March 6, 2026

Project No. M1750.01.001

Re: 21st Century Towing—2026 Long-term Soil Cap Monitoring, Maintenance, and Soil Management Plan Addendum (ECSI Site #1050)

Figure 1
Waste Soil Site Plan

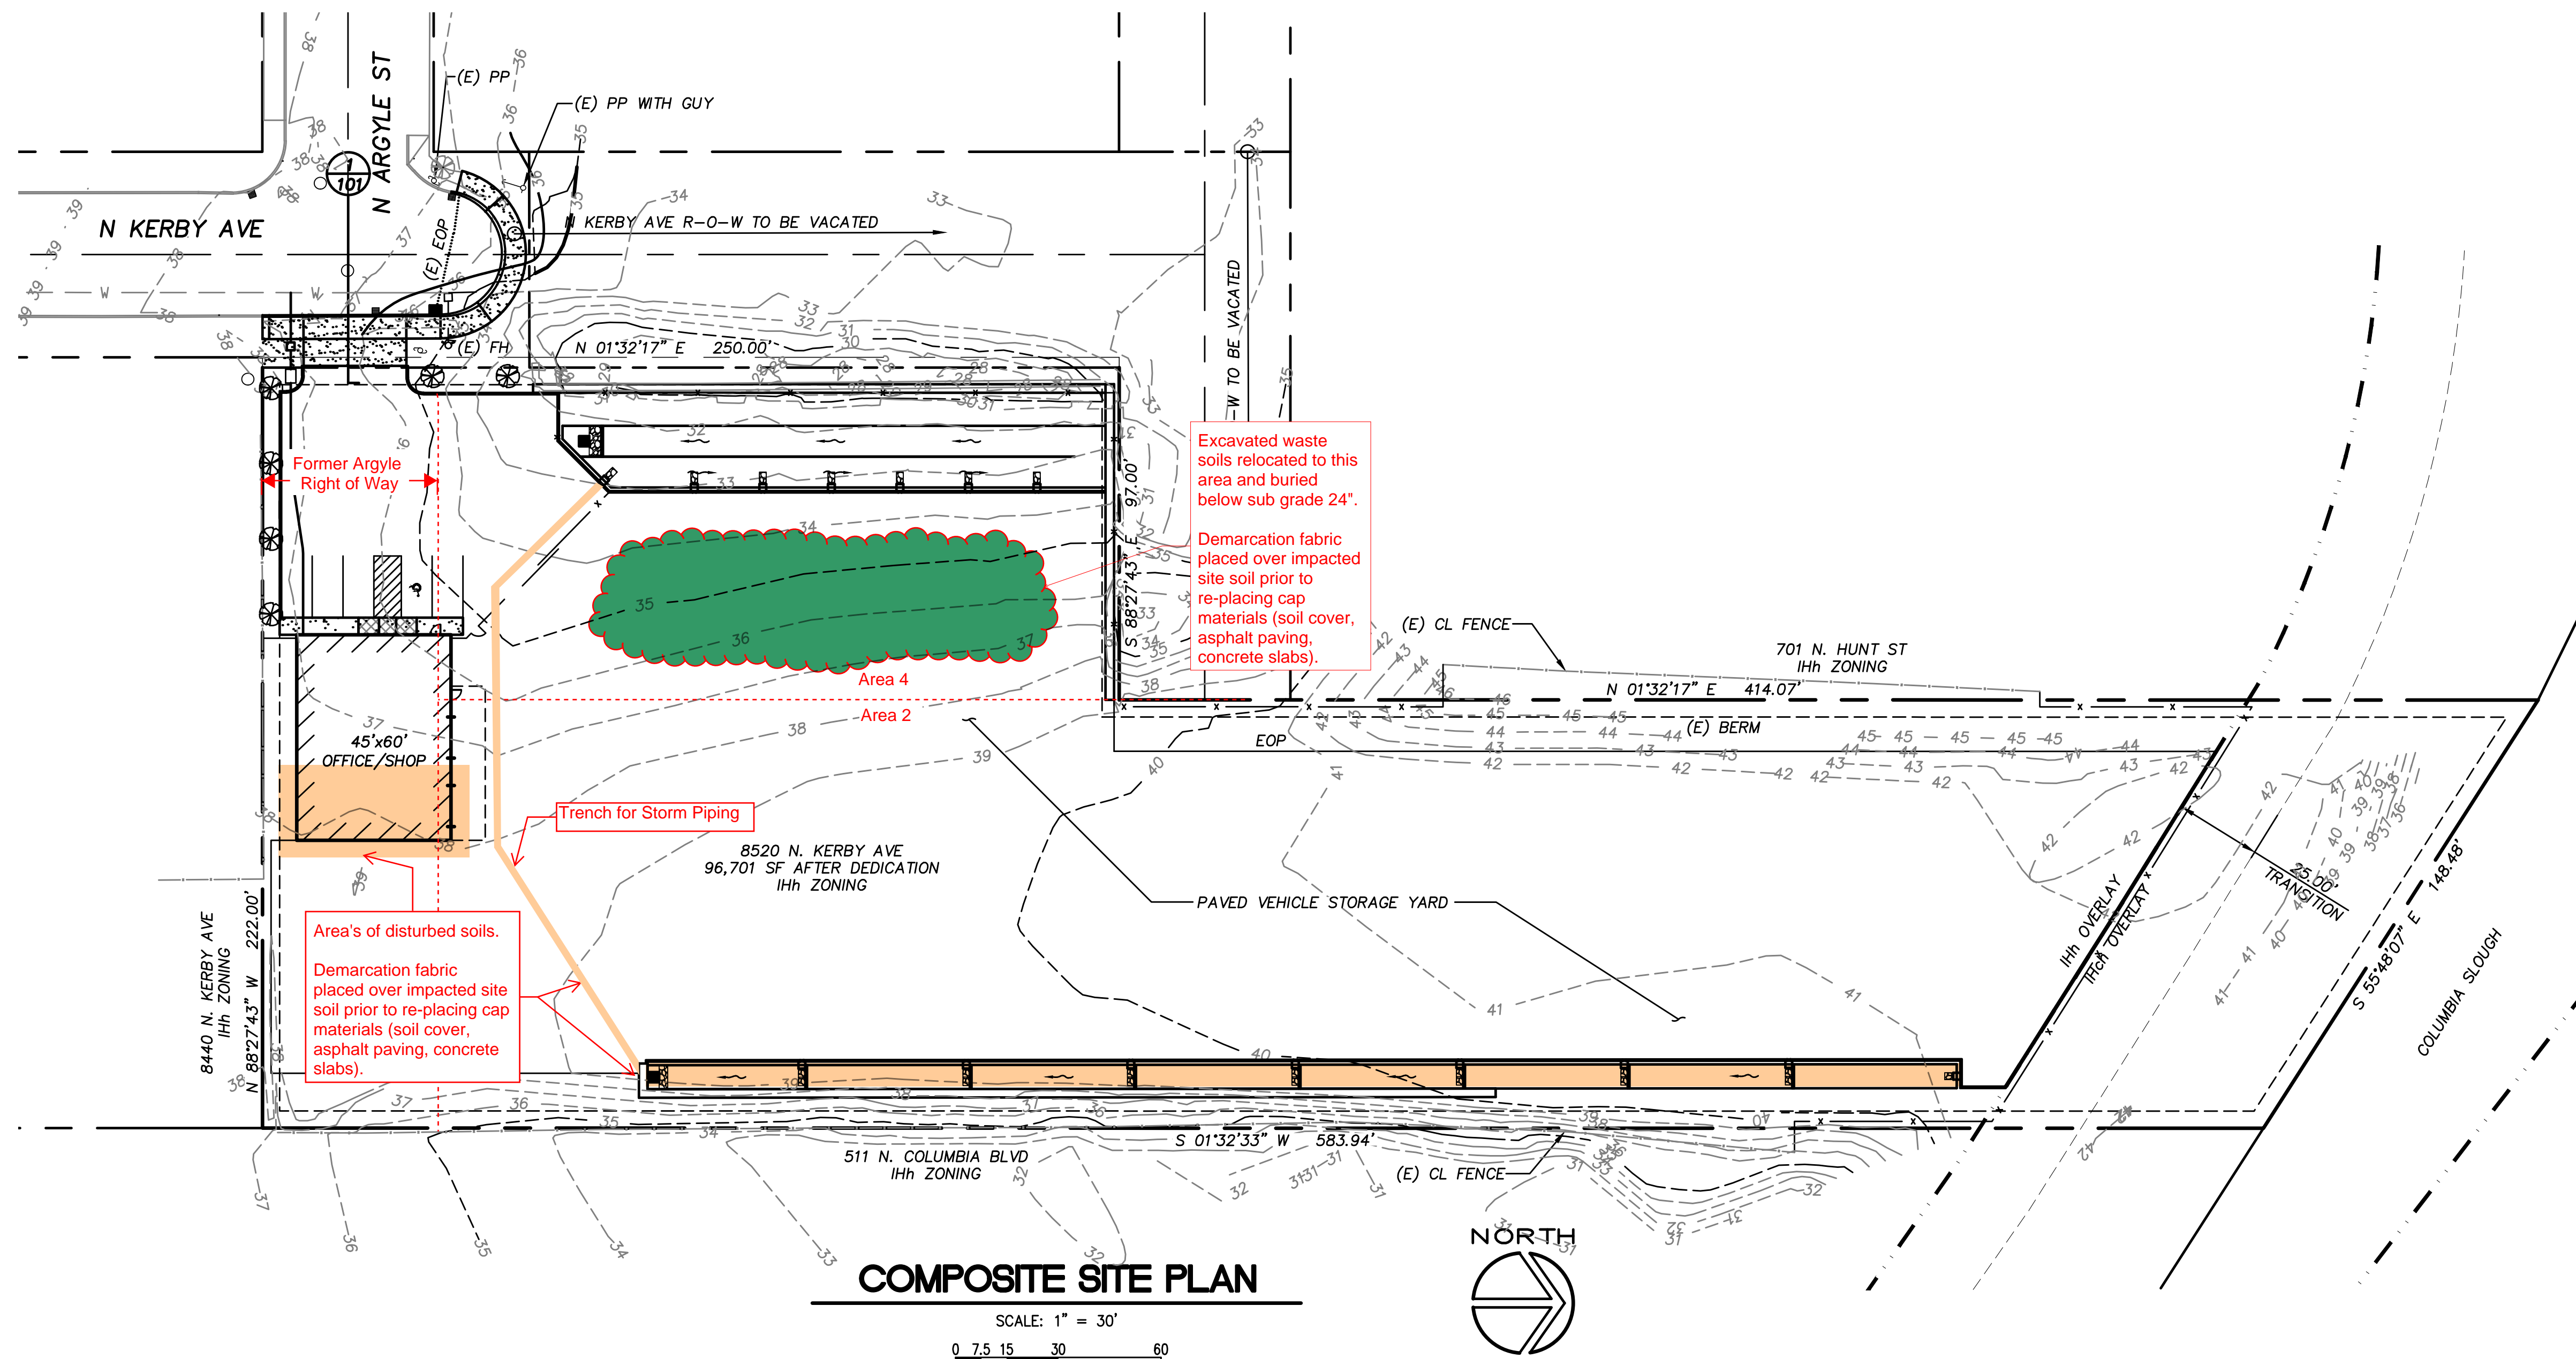
Approximately 225 cubic yards of excavated waste were relocated to a consolidation area onsite and covered with demarcation fabric before construction of the protective surfaces (see Figure 1). Redevelopment activity resulted in minor regrading of the Site and construction of new impervious surfaces that augment the clean soil cap, in the form of asphalt paving/base rock, high-density polyethylene (HDPE)-lined stormwater treatment swales, and a concrete building slab over HDPE liner with passive vent (see Figure 2). Excavations that fully penetrated the previously established soil cap were lined with demarcation fabric before placement of backfill or cover material.

Figure 3
Methane Barrier, Vent, and Sampling Port Locations

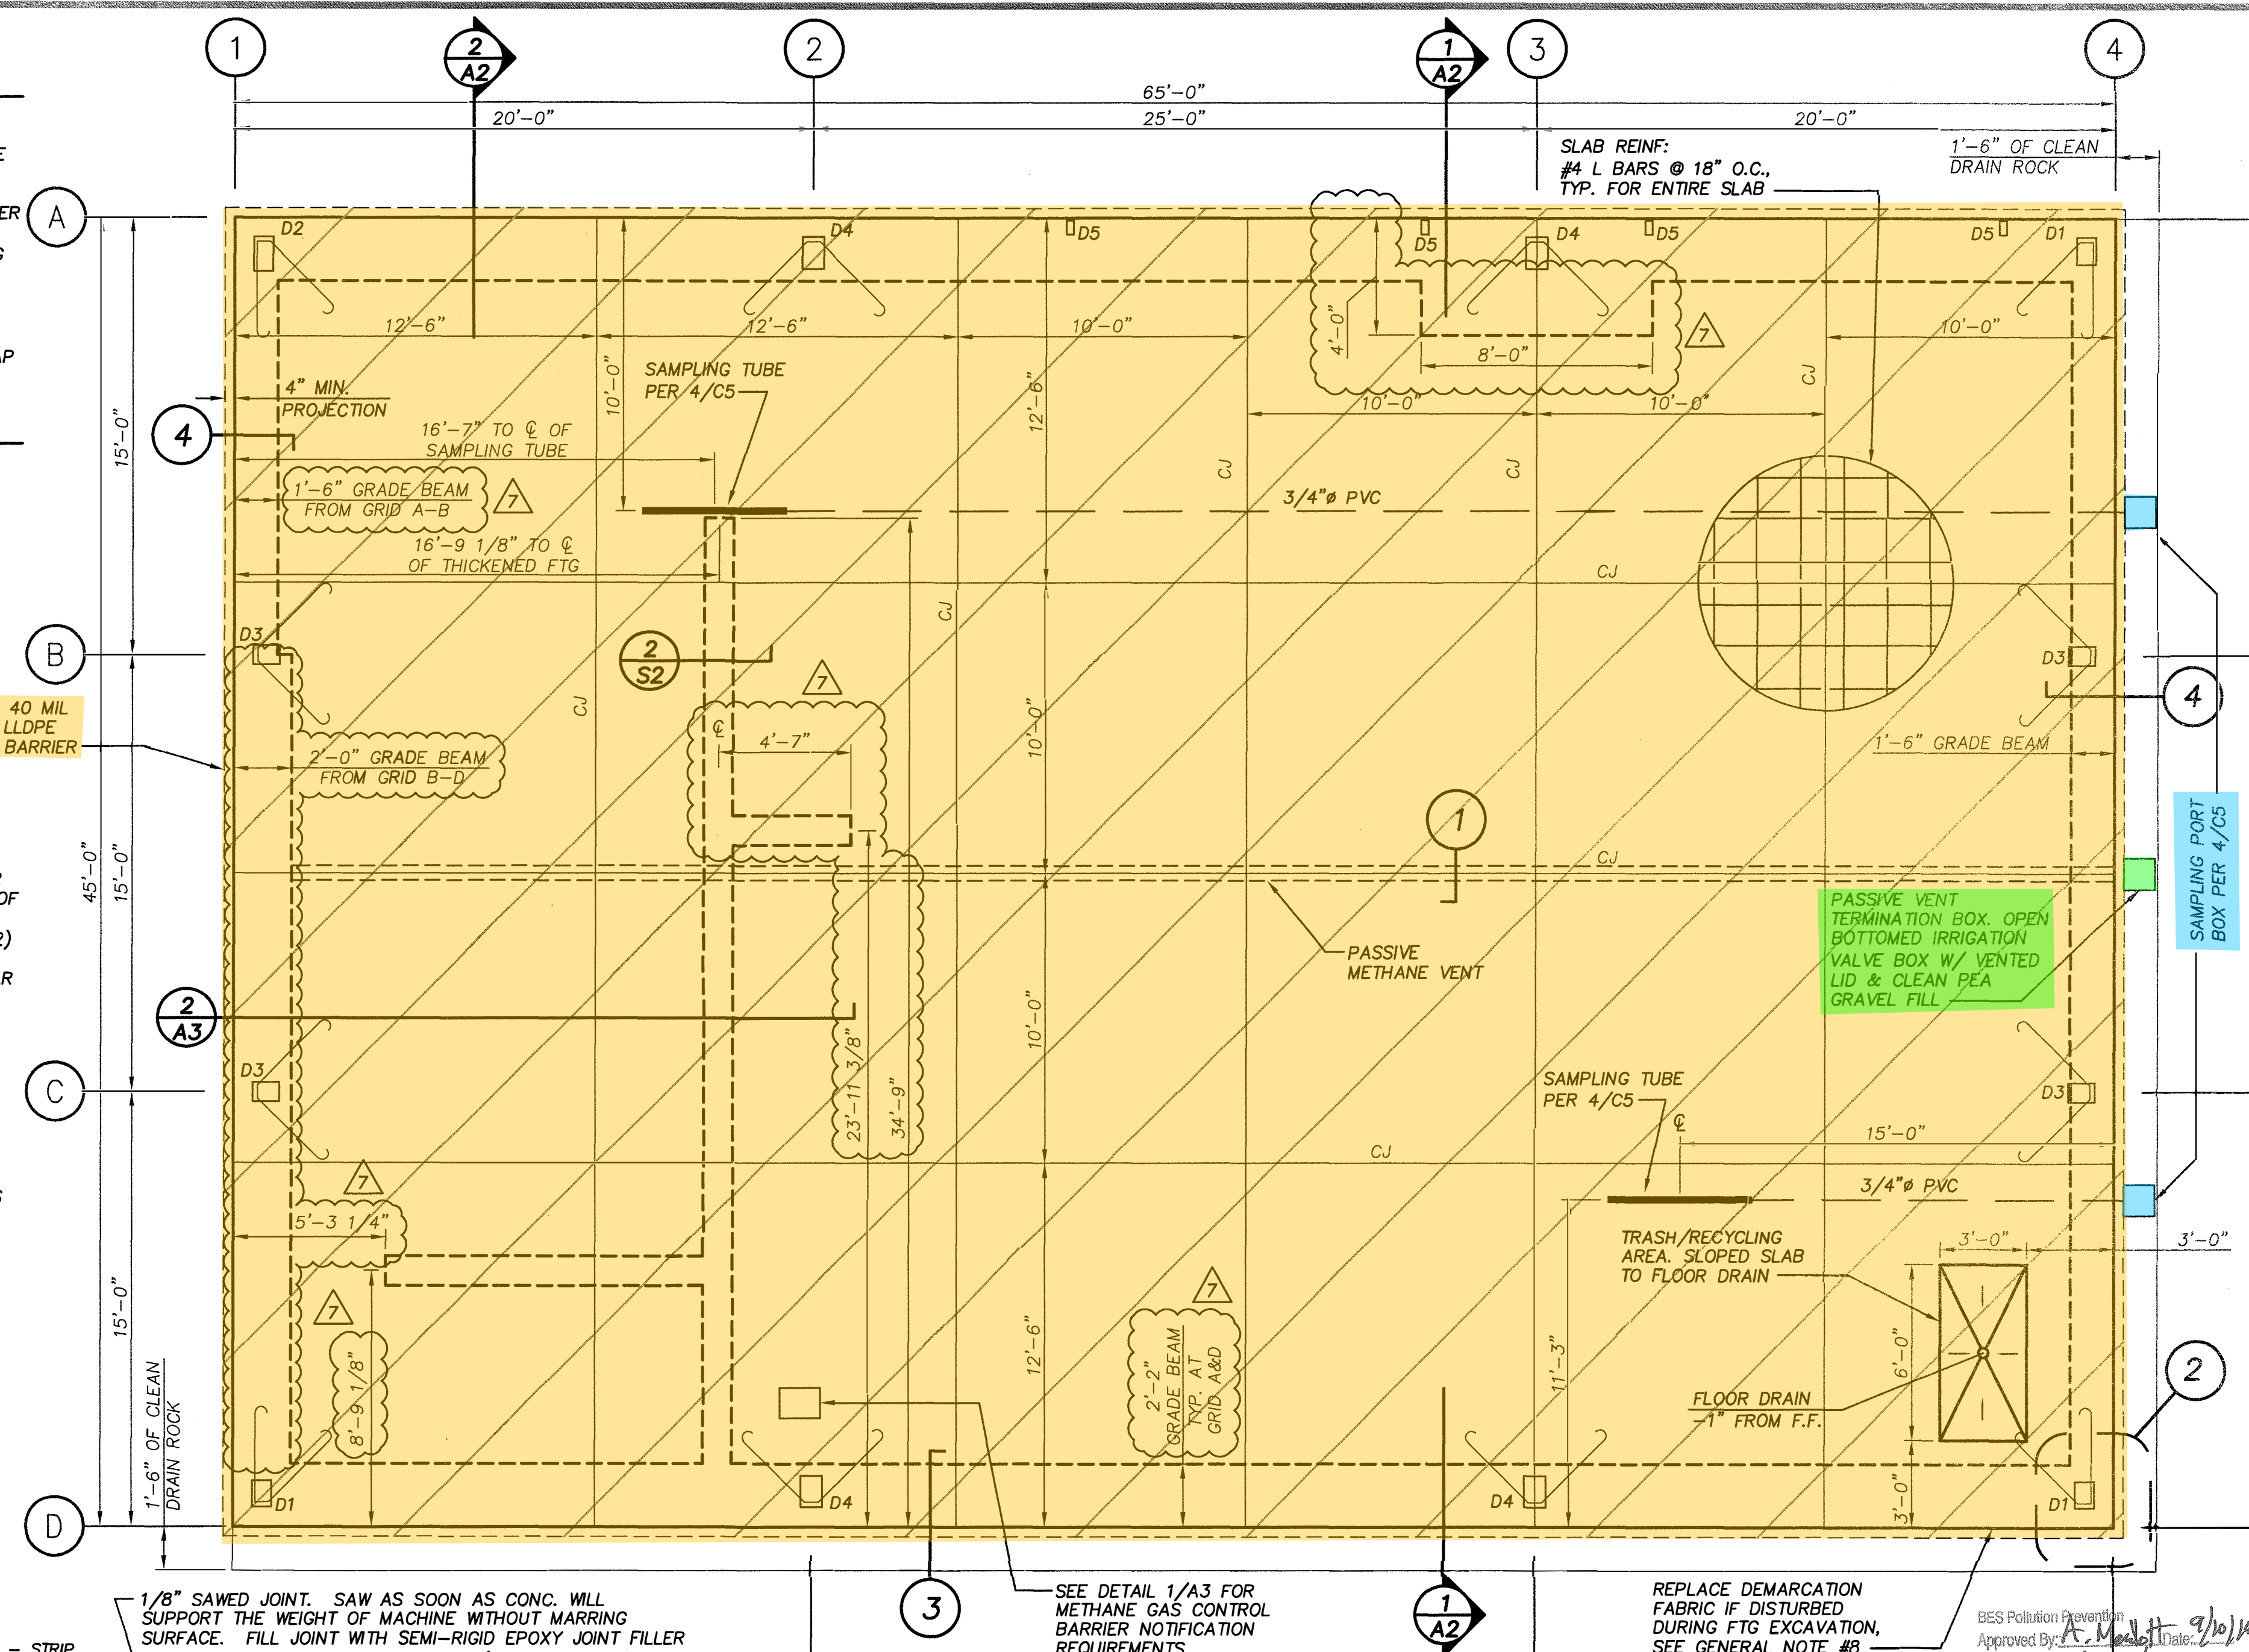
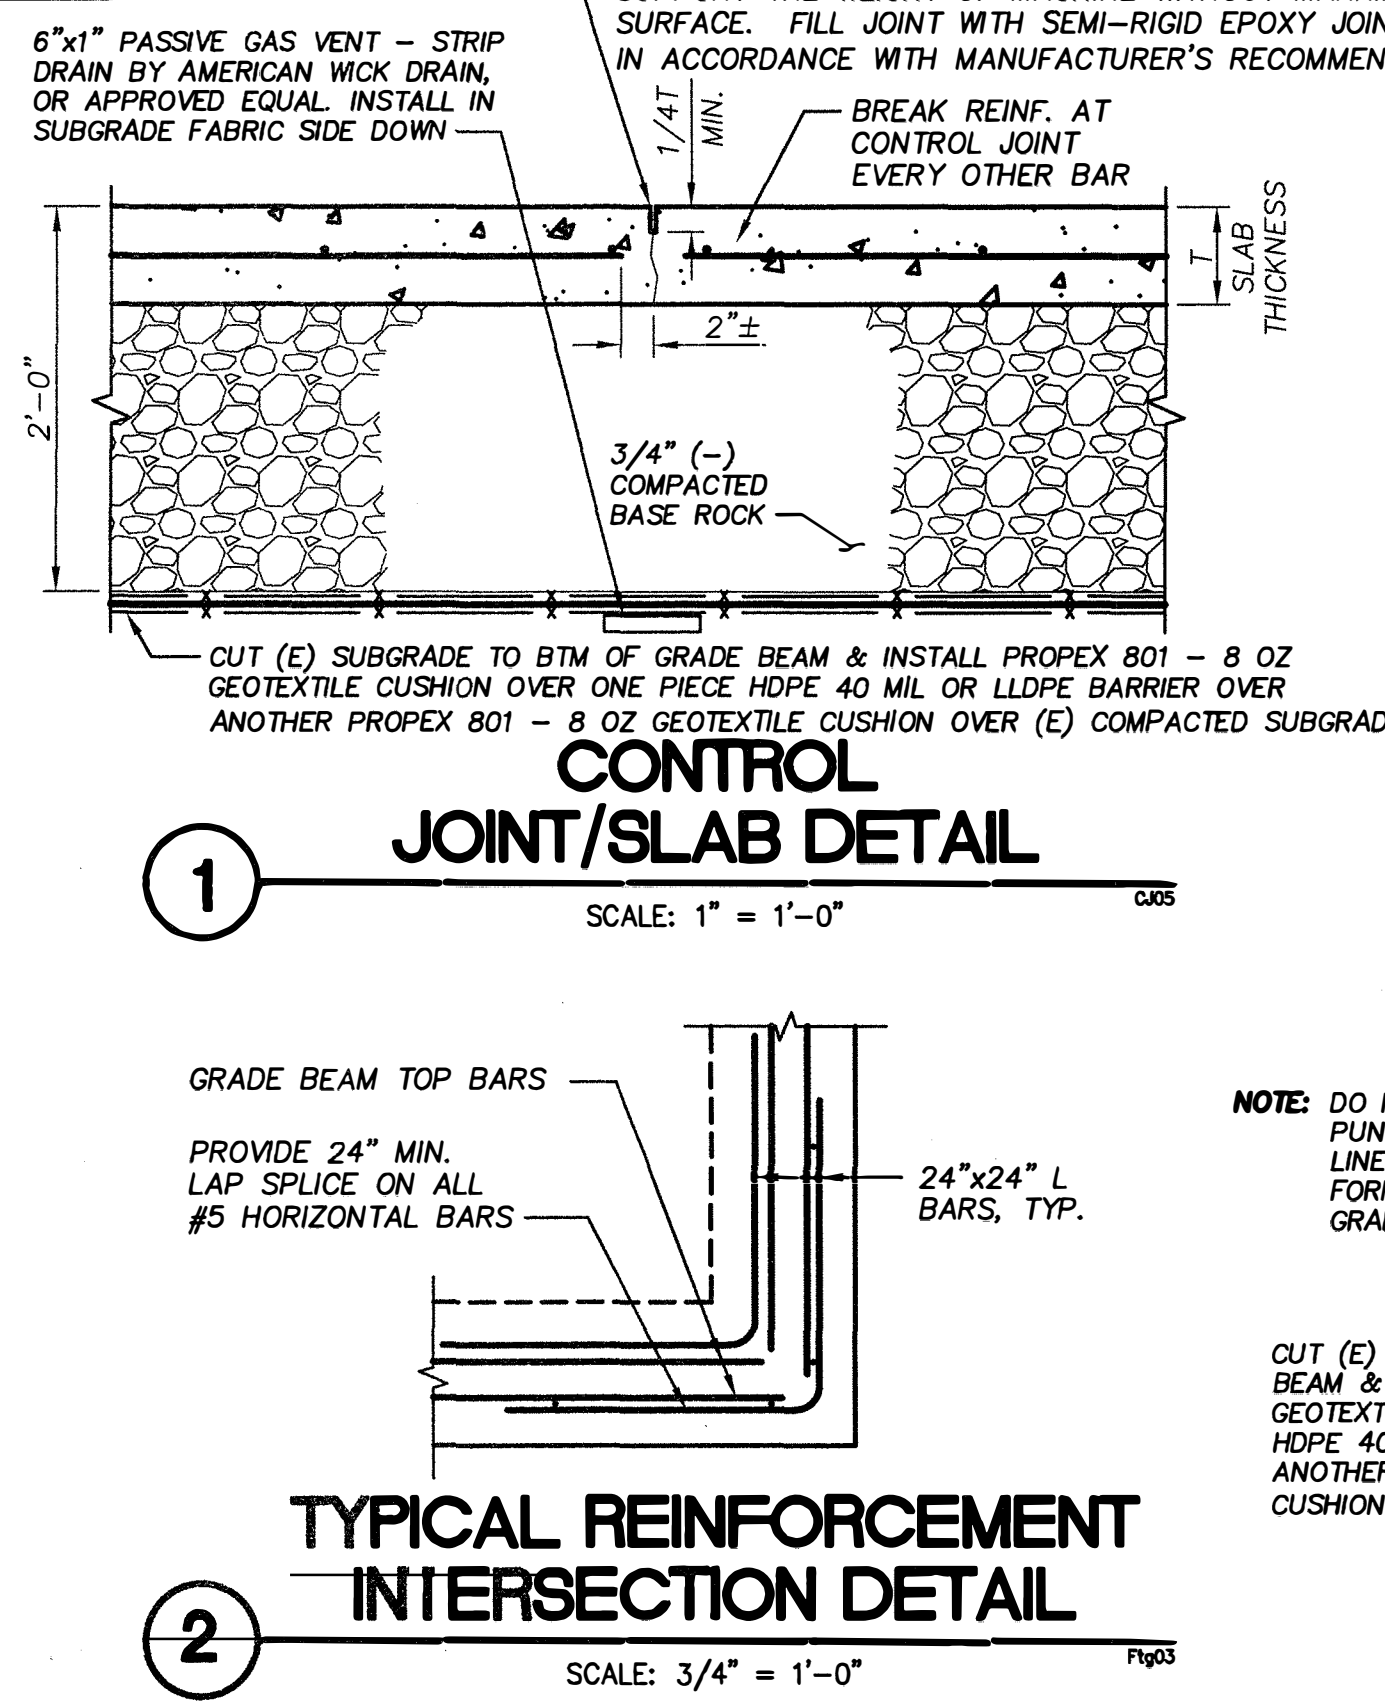
The concrete slab for the office/shop building was constructed over a 40-mil, HDPE geomembrane liner to prevent migration of methane gas into occupied areas. The geomembrane was constructed over a 6-inch-wide, passive ventilation strip drain (fabric side down) and then covered with approximately 18 inches of compacted base rock. Two methane monitoring ports were constructed over the geomembrane and below the concrete building slab. The monitoring ports are ¾-inch-diameter polyvinyl chloride pipe with 5 feet of slotted screen, as shown in the approved plans. Figure 3 shows the locations of the methane barrier, sampling ports, and the passive vent.

Future penetrations of the building slab shall be made with caution. Any activity, whether planned or accidental, that results in penetration of the geomembrane beneath the building requires consultation with an environmental engineer and notification of the DEQ.
